20 September 2022
Our Ref: 21BRT0549
Your Ref: DEV2022/1310

RE: 15 Nexus Way Southport, Traffic Response to Further Issues

TTM has been engaged to respond to further issues letter for a proposed health care use at the above address. This request from Economic Development Queensland is dated 9 September 2022 and refers to Application Number DEV2022/1310.

Drawing
LEVEL B1 GENERAL ARRANGEMENT PLAN

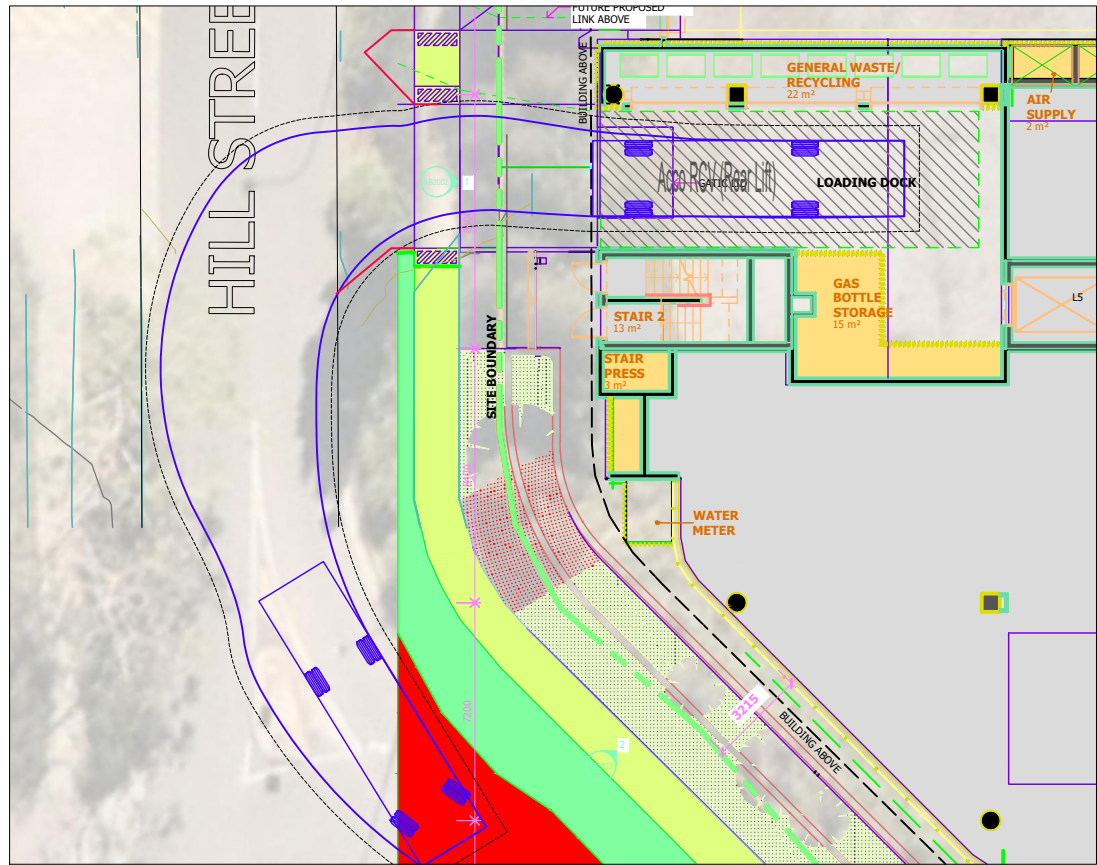
Item 3(a) of the EDQ letter asks to remove parking spaces 34 and 105 to provide pedestrian access to the lifts.

Item 3(q) of the EDQ letter requests confirmation of how cyclists will access the EoT facilities with the ambulance bay an space 14 occupied.

Item 3(s) of the EDQ letter requests further justification for clearance to columns.

Rather than removing these spaces the plan of development has been amended to locate these spaces as close a practical to the wall adjacent to the basement vehicle ramps. The 300mm wall clearance, adjacent to a 2400mm wide parking space, retains approximately 980mm clearance for pedestrians. This is sufficient to provide thoroughfare between the lift lobby and the southern parking aisle.

The updated plans of development shown in **Appendix A** identify a marked 1.3m wide path to provide access for cyclists to access end of trip facilities. Actual clearance is generally expected to be greater to a parked vehicle as cars do not typically park up to the painted line.

The updated plans of development shown in **Appendix A** identify a parking envelopes for critical spaces demonstrating clearance to columns for door opening. Where the majority of spaces are located adjacent to 400mm wide columns, the spaces are separated by 600mm. This provides an extra 100mm clearance for access manoeuvring and door opening, such that the slight intrusion of the column length is mitigated.

PROJECT
HILL STREET, SOUTHPORT
DRAWING TITLE
**VEHICLE ACCESS ARRANGMENTS
RCV SWEEP PATH ANALYSIS**

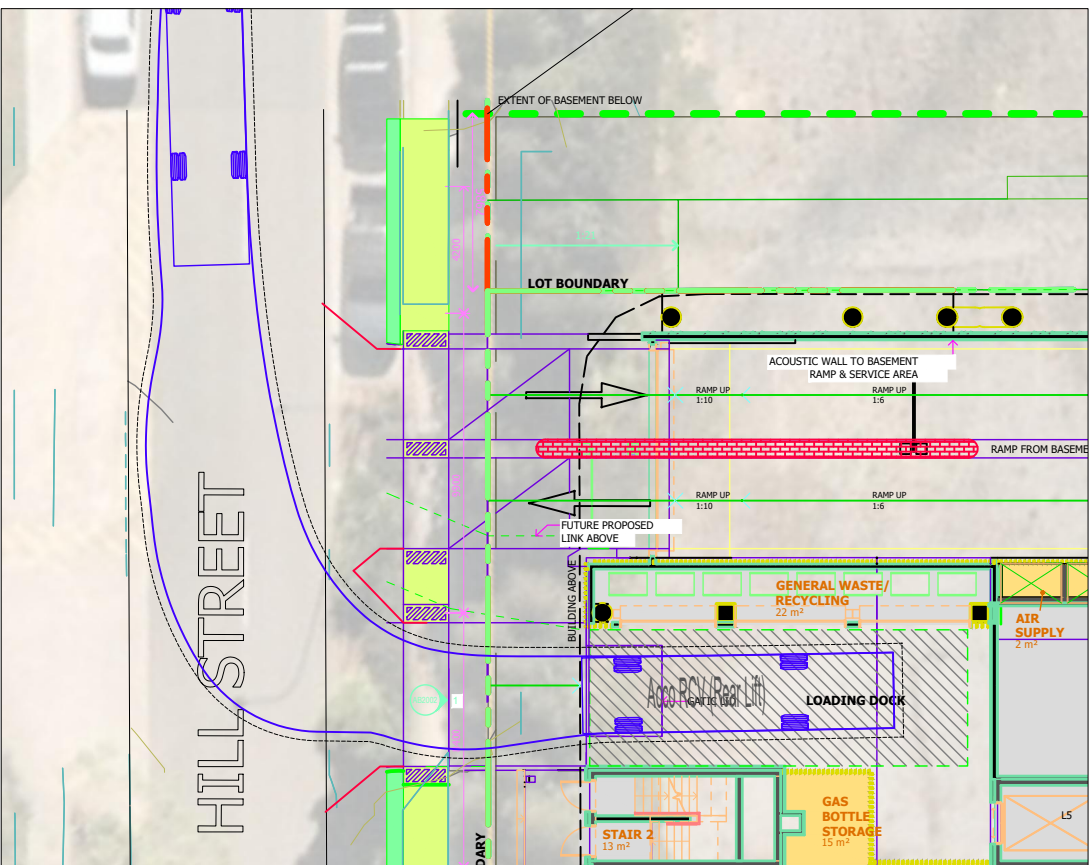
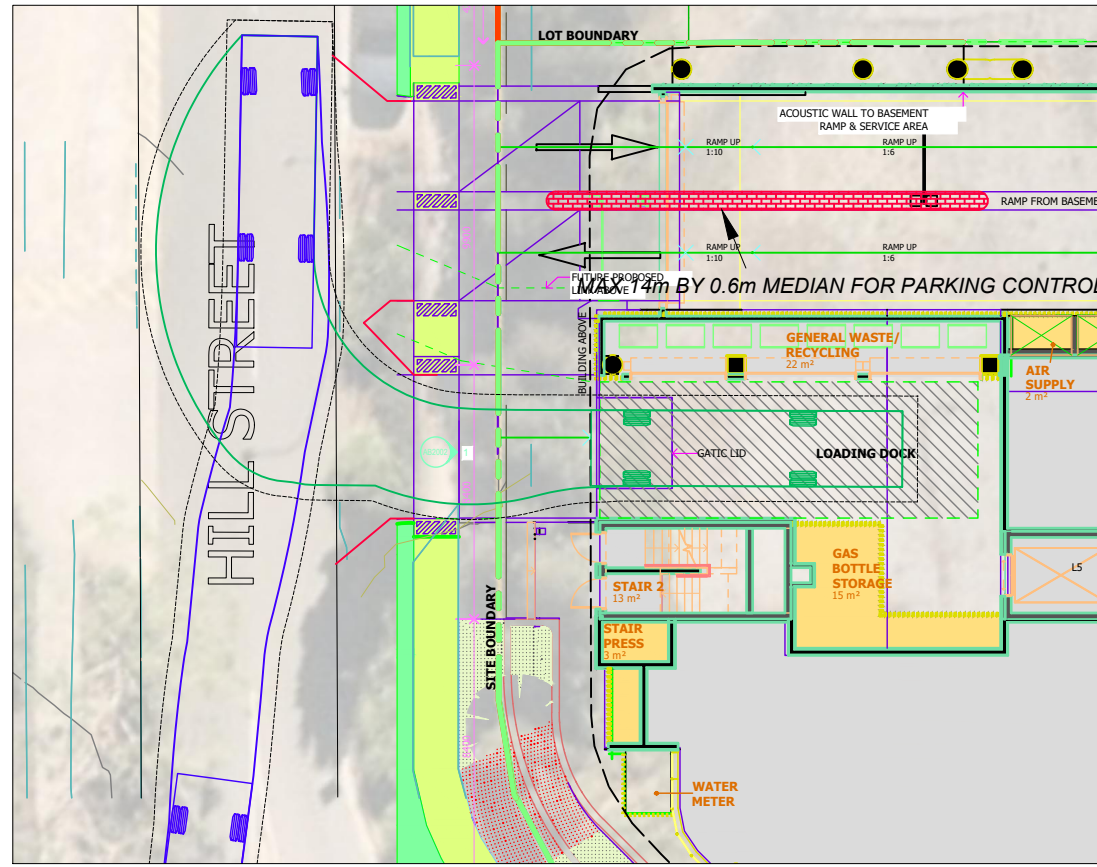
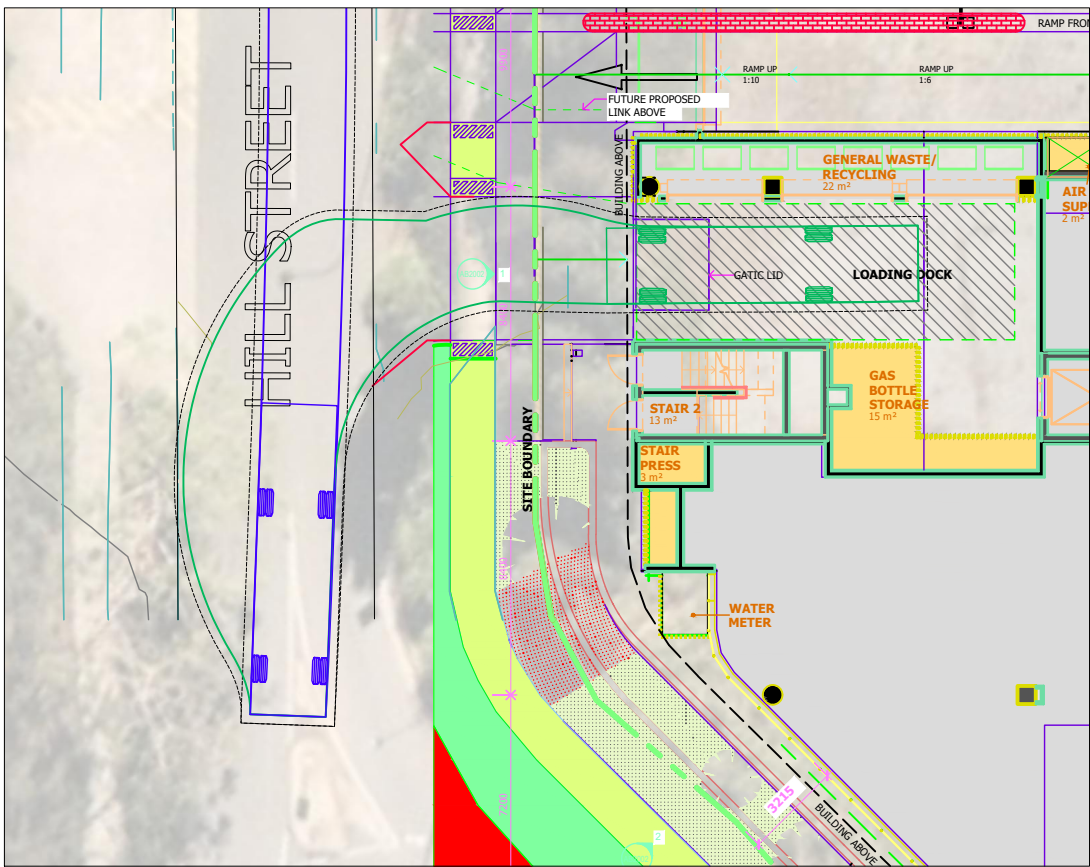
Item 3(j) of the EDQ letter requests swept paths of the RCV and SRV are provided for both directions along Hill Street vehicle accessing this loading bay.

This full set of paths is shown in **Appendix B**.

PROJECT
HILL STREET, SOUTHPORT
DRAWING TITLE
**BASEMENT 1 VEHICLE ACCESS
SWEEP PATH ANALYSIS**

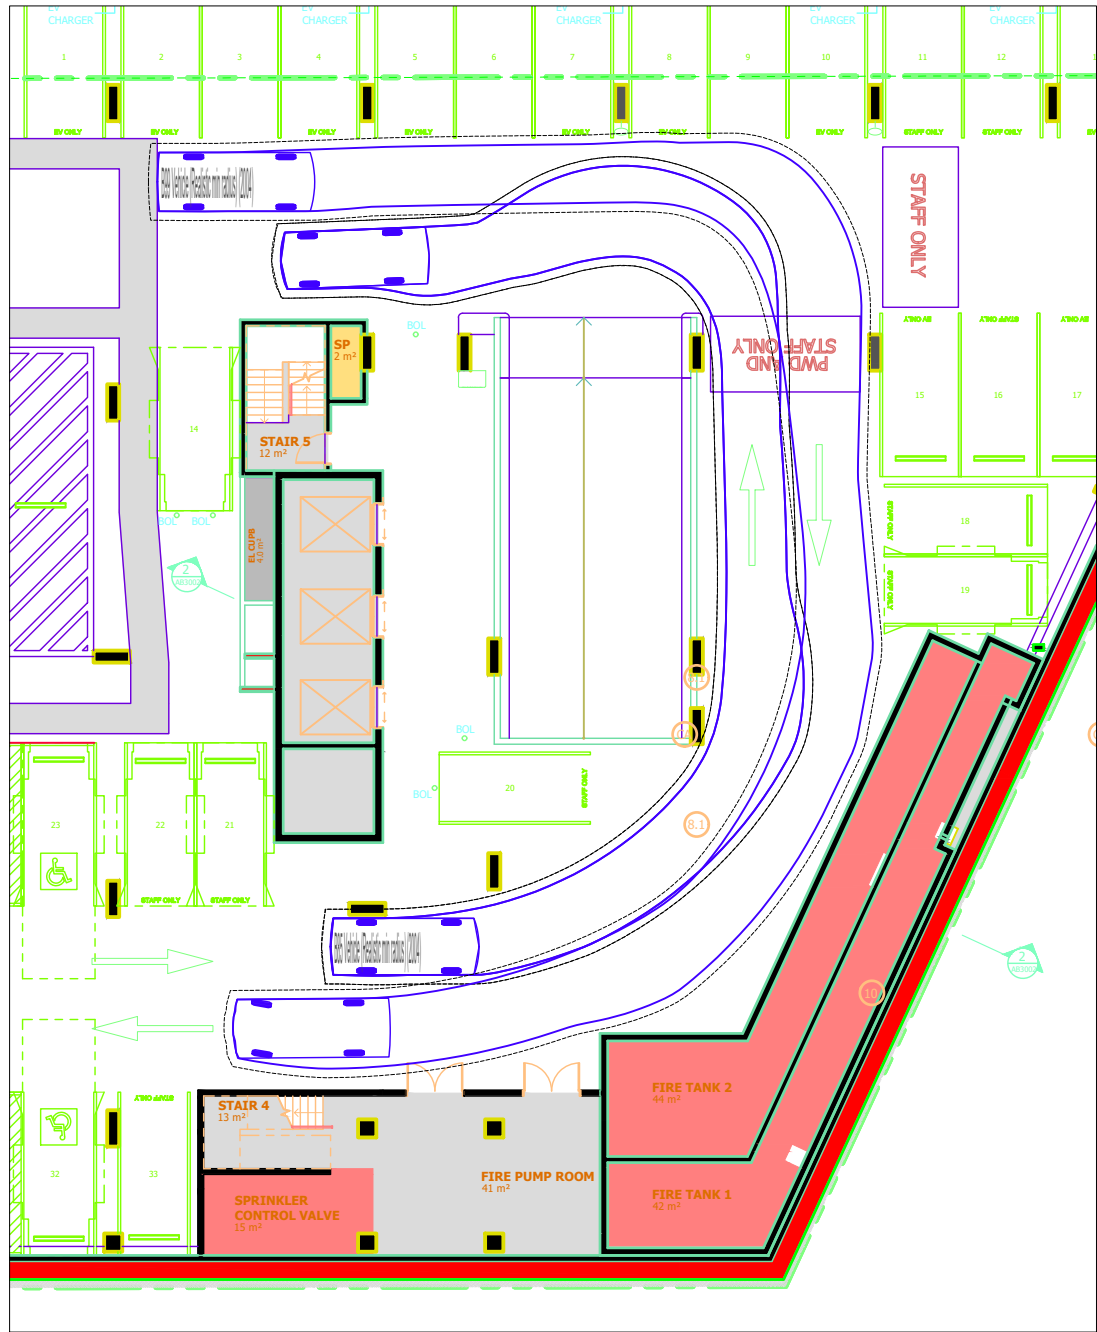
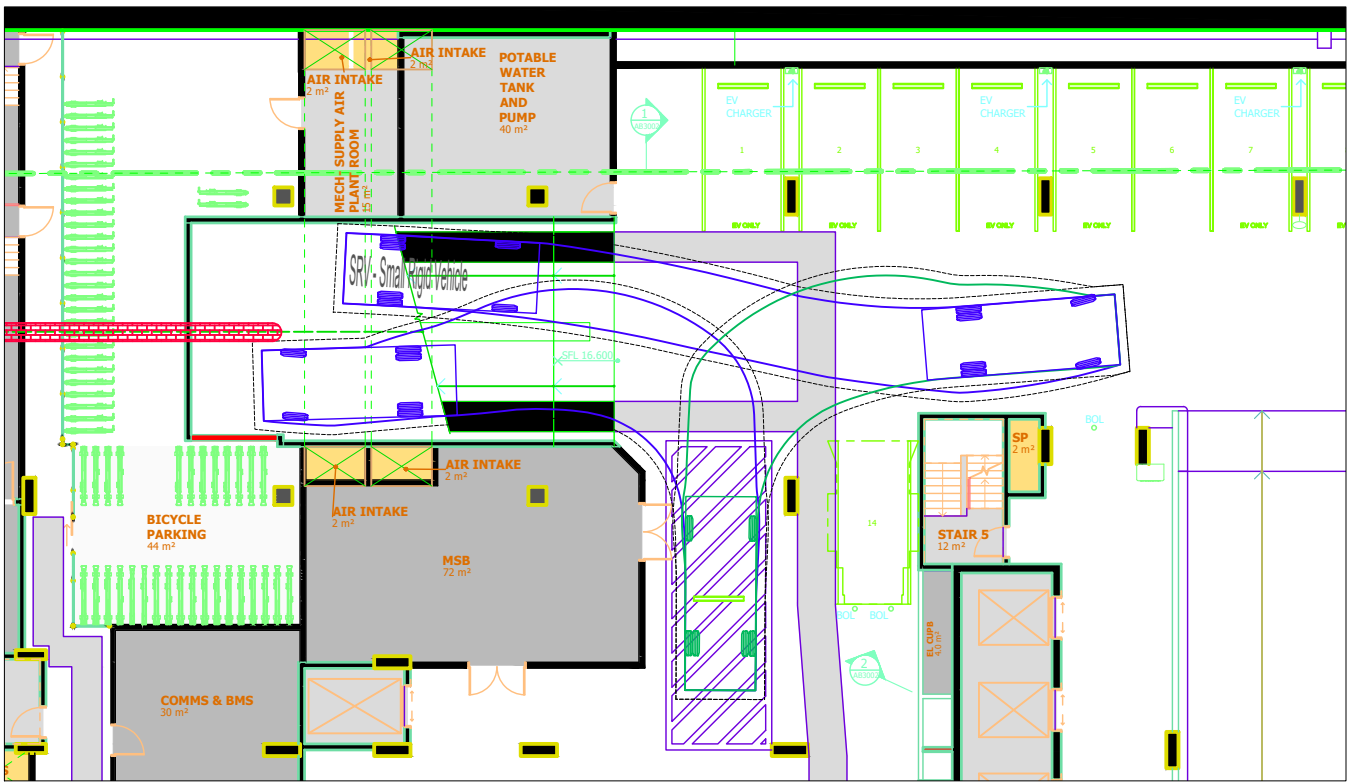
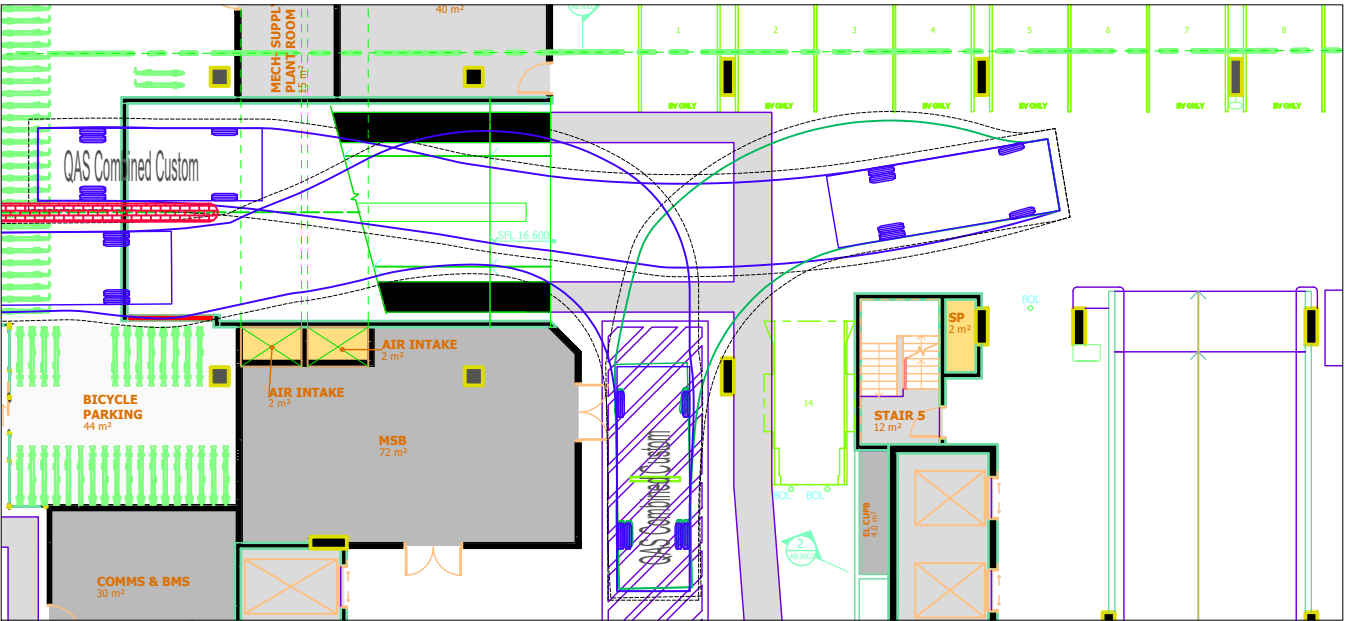
Item 3(l) of the EDQ letter requests swept paths of SRV and ambulance are shown to have clearance to boom gates including 600mm on curved sections.

Item 3(m) of the EDQ letter requests swept paths of the SRV are 300mm clear to parking bay.

This full set of paths is shown in **Appendix B**.

This full set of paths is shown in **Appendix B**.
